# UNITED STATES PATENT AND TRADEMARK OFFICE

APPLICATION NO.	FILING DATE	FIRST NAMED INVENTOR	ATTORNEY DOCKET NO.	CONFIRMATION NO.
10/526,432	08/12/2005	Eiichi Yasuda	267135US26X PCT	3010
22850	7590	04/08/2008		
OBLON, SPIVAK, MCCLELLAND MAIER & NEUSTADT, P.C. 1940 DUKE STREET ALEXANDRIA, VA 22314			EXAMINER WILSON, KAITLIN A	
			ART UNIT	PAPER NUMBER
			3636	
			NOTIFICATION DATE	DELIVERY MODE
			04/08/2008	ELECTRONIC

<b>Office Action Summary</b>	<b>Application No.</b> 10/526,432	<b>Applicant(s)</b> YASUDA ET AL.	
	<b>Examiner</b> KAITLIN A. WILSON	<b>Art Unit</b> 3636

### **DETAILED ACTION**

Fig. 9

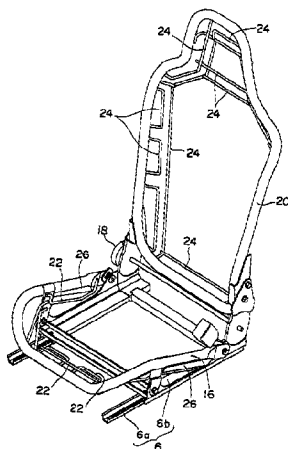
2. In re Claim 1, with reference to Figures 9,16 and 17 Fujita et al. discloses a seat (S) comprising:

- a seat frame including a sitting portion frame (16) and a back portion frame (20)
- a planar tension structure (8) attached to the sitting portion frame (16) or the back portion frame (20); and
- an elastic supporting structure (52,54) that supports the planar tension structure (8) between the sitting portion frame (16) or the back portion frame (20) and the planar tension structure (8), such that directions of tensions acting on the planar tension structure (8) extend in three directions.

9. The examiner notes that the Y and Z components of the spring (52) and the X component of the spring (54) produce a tension in three directions.

15. In re Claim 17, with reference to Figures 9,16 and 17 Fujita et al. ('487) discloses a seat comprising:

- a frame for a sitting portion (16)
- a cushion material including a lower layer portion (15) stretched in a front-rear direction at the frame for the sitting portion (16), and a surface layer portion layered on the lower layer portion and stretched at the frame for the sitting portion (10) (col. 13, lines 13-18); and
- a tension adjusting mechanism (52,54) connecting connection positions at the lower layer portion (15) in vicinities of beneath ischial tuberosities of a seated person and portions at the frame for the sitting portion (16) which portions are lower than the connection positions, and generating tensile force at a time of sitting.

Fig. 16

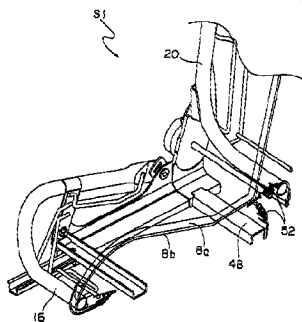
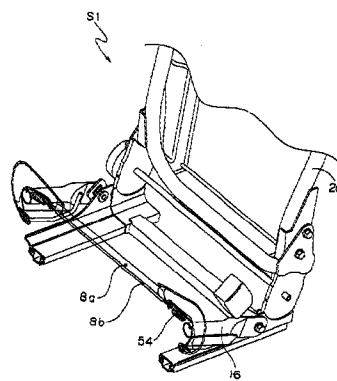
12. In re Claim 4, as best understood, with reference to Figures 11 and 16, Fujita et al. disclose that a front end of the planar tension structure is fixed to the sitting portion frame (16), and wherein the elastic supporting structure includes a first elastic member (52) which, at the time of sitting pulls a rear end of the planar tension structure rearward.

13. In re Claim 5, as best understood, with reference to Figures 11 and 16, Fujita et al. disclose wherein the elastic supporting structure includes a second elastic member which is provided between the sitting portion frame and the planar tension structure, and which, at a time of sitting, pulls downward.

14. In re Claim 6, as best understood, with reference to Figures 16 and 17, Fujita et al. disclose inherently disclose that the second elastic member (13) pulls the planar tension structure such that maximum flexing at the time of sitting arises rearward of a front-rear direction central portion at the time of sitting.

35. In re Claim 13, as best understood, with reference to Figure 17, Fujita et al. disclose a connection member (54) which connects the seat frame and a portion of the cushion material corresponding to the region that the specific region of the human body pushes, and which functions as an elastic member which generates tensile force at the time of sitting.
